Lancia Phedra - Poor cooling performance | HELLA

Poor cooling performance

Delayed temperature regulation

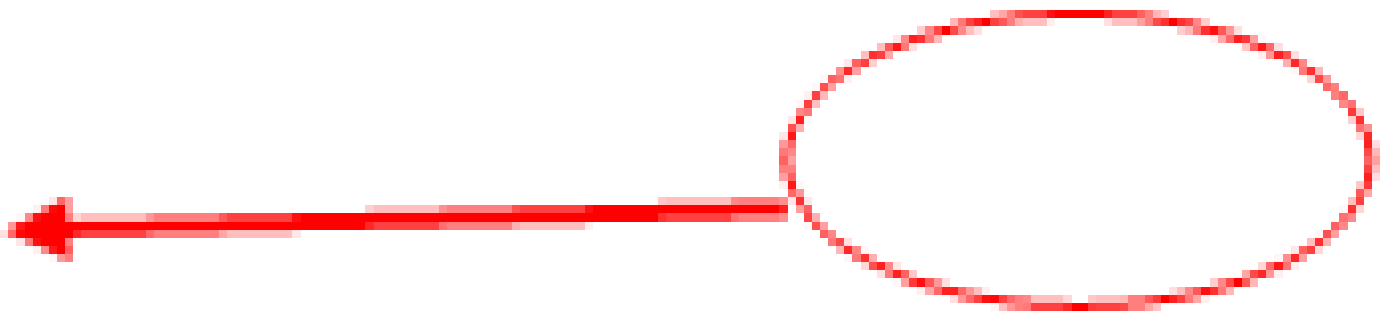
On the above mentioned vehicles it is possible that selected temperature changes in the "cold" direction are only

implemented with a delay. During the first few minutes after the temperature change, warm air is still output. In many cases this problem is caused by a faulty air-conditioning control unit. The replacement of the control unit can often rectify the problem. The modified control unit is marked with the identifier "S40" (see drawing). This identifier should also be on the replacement part.

If a modified unit has already been fitted, the system is to be checked for the cause of the problem.
